Kingscliff Public School Redevelopment

State Significant Development Assessment

SSD-8378620

December 2021

Figure 22 | Drop-off / pick-up zone on Orient Street (Base source: EIS 2021)

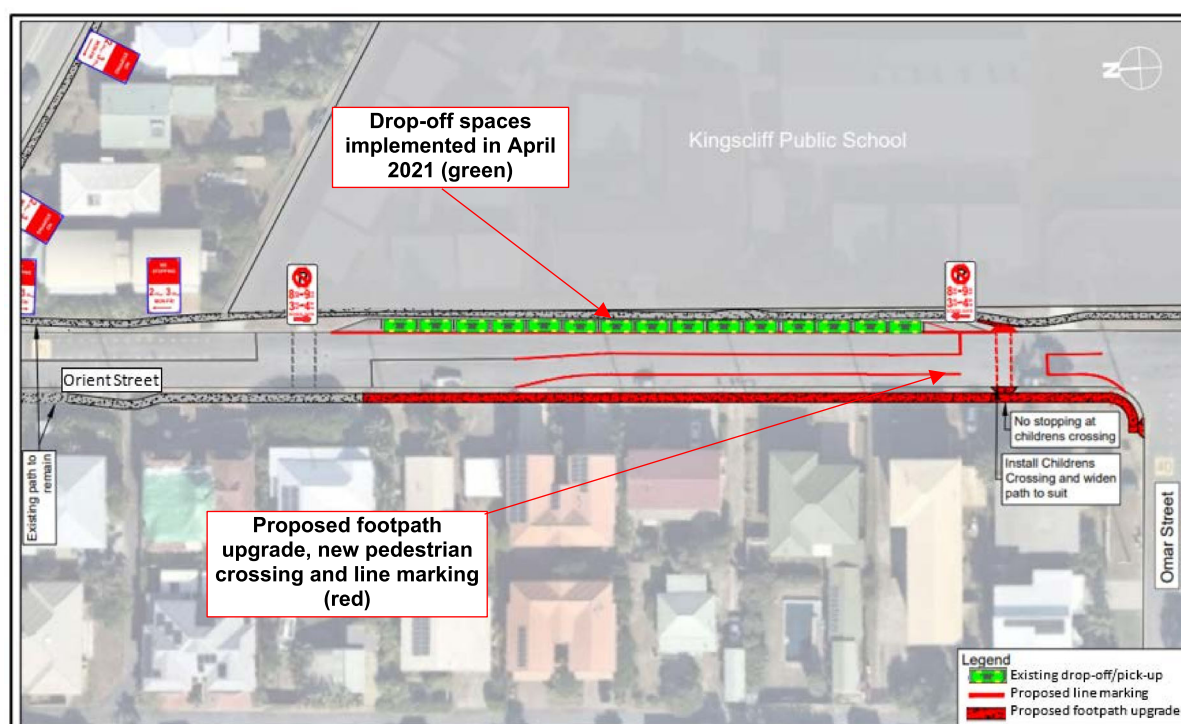
Council's EIS submission requested that the proposed drop-off / pick-up zone on Orient Street be revised to address potential traffic congestion on Sutherland Street as a result of queuing. TfNSW requested the Applicant consult further with TfNSW and provide detailed drawings for the consolidated drop-off / pick-up zone and bus zones.

The RtS noted the Applicant had consulted Council and completed the drop-off / pick-up and bus zone consolidation works in April 2021 under relevant Council approvals under the *Roads Act 1993*. The drop-off / pick-up zone on Orient Street is shown in **Figure 22** and provides space for 15 cars.

Figure 23 | Proposed signage along the Sutherland Street and Orient Street intersection
(Source: RtS 2021)

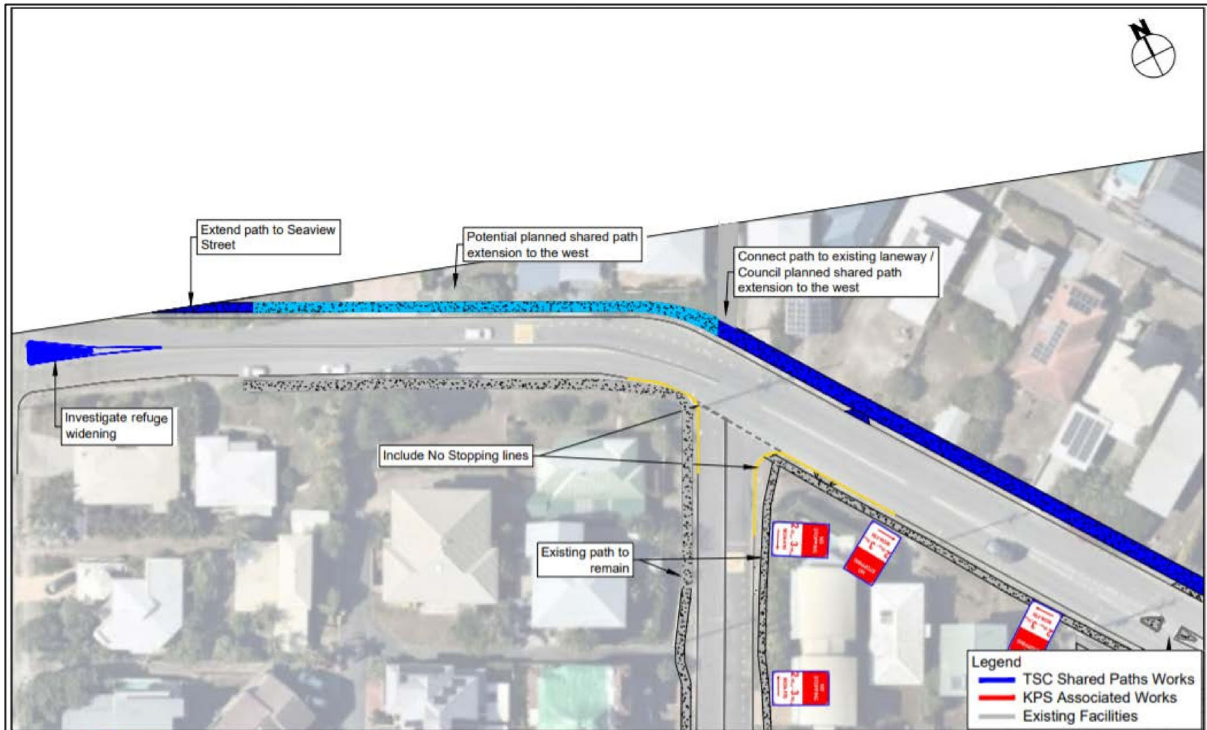
In response to public submissions, the RtS stated that the proposal has been designed to avoid use of other roads for drop-off / pick-up, including Hungerford Lane, to reduce vehicle movement on residential streets. The Applicant acknowledged that the narrow width of Orient Street meant that when cars were parked for students to disembark / embark, traffic needed to move into the opposite side of the carriageway to pass the parked vehicles. To improve the safety and efficiency of the drop-off / pick-up operations, the Applicant provided amended plans to include additional works including:

- 'No Stopping' signage at the new pedestrian crossing on Orient Street
- timed 'No Parking' zones in the drop-off / pick-up zone
- timed 'No Stopping' zones on the eastern side of Orient Street

- additional line marking along Orient Street to further demark the drop-off / pick-up zone, the travel lane and street parking
- additional signage to prevent incorrect drop-off / pick-up driving behaviour close to the intersection of Sutherland Street and Orient Street (**Figure 23**).

Figure 24 | Pedestrian infrastructure and deficiencies (Base source: EIS 2021)

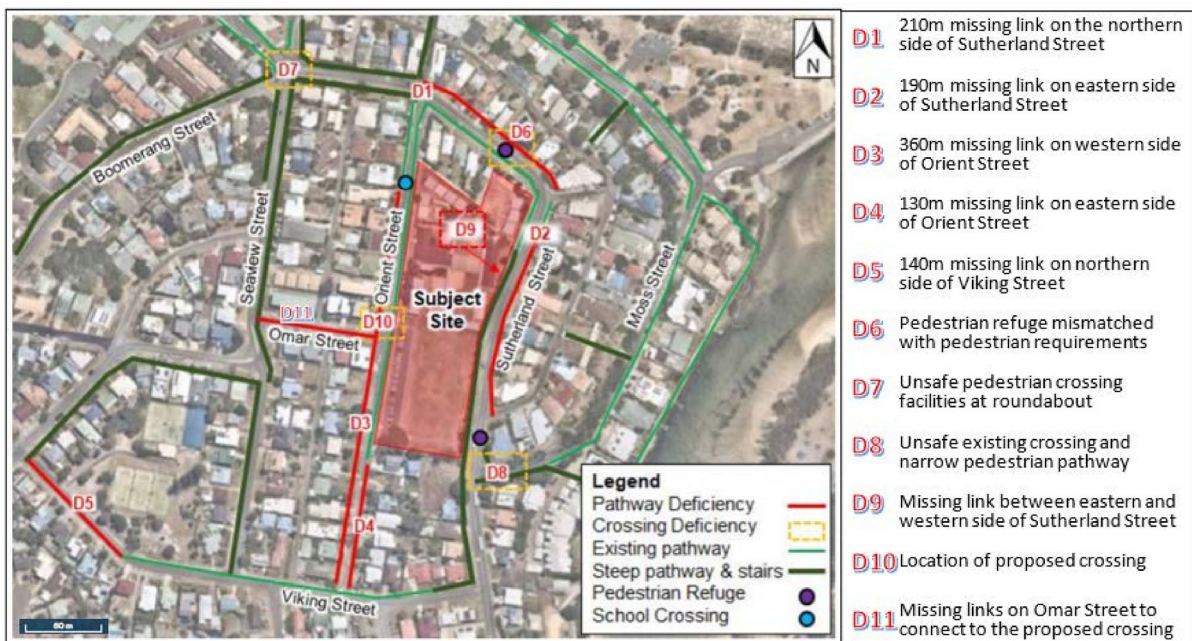
Public submissions raised concerns in relation to the existing pedestrian infrastructure for students accessing the site from the east.

Council supported the revised proposals in the RtS and recommended conditions to ensure all pathway upgrade works are constructed to its requirements. TfNSW noted the additional works proposed and recommended that the detailed design be undertaken in consultation with Council and the Local Traffic Committee.

Figure 25 | Location of additional parking proposed on Sutherland Street (Source: Applicant's RtS 2021)

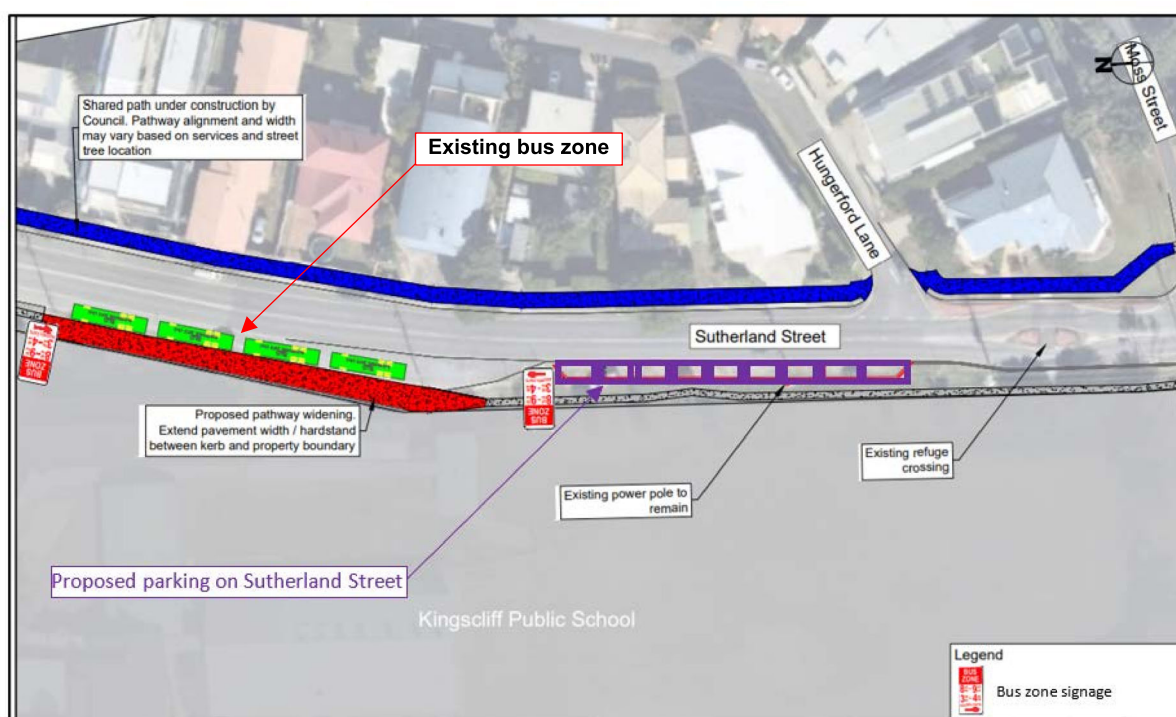
In its submission to the EIS, Council objected to the proposed development on the basis that it did not provide sufficient parking to accommodate demand by staff. Council requested the Applicant provide 13 additional on site car parking spaces, to provide a total of 45 parking spaces for staff. Council also noted that the proposal did not adequately address existing informal parking along the grassed verge of Sutherland Street.

Whilst Council advised that it supported the proposed parking spaces on Sutherland Street, it stated that the spaces on Sutherland Street would most likely be used by parents, not staff. To ensure sufficient parking for parents and staff, Council requested that an additional 13 spaces be constructed on Orient Street (**Figure 26**). This would provide a total of 54 parking spaces on and around the school. Council stated that the provision of indented spaces on Orient Street would also assist in improving traffic flow when vehicles are parked on both sides of the southern end of Orient Street.

In response to Council's comments, the RtS stated the Applicant had consulted Council regarding parking arrangements. As a result of that consultation, the Applicant amended the proposal to include construction of nine parking spaces on the grassed verge of Sutherland Street, to provide a total of 41 staff spaces. The location of the proposed spaces is shown in **Figure 25**.
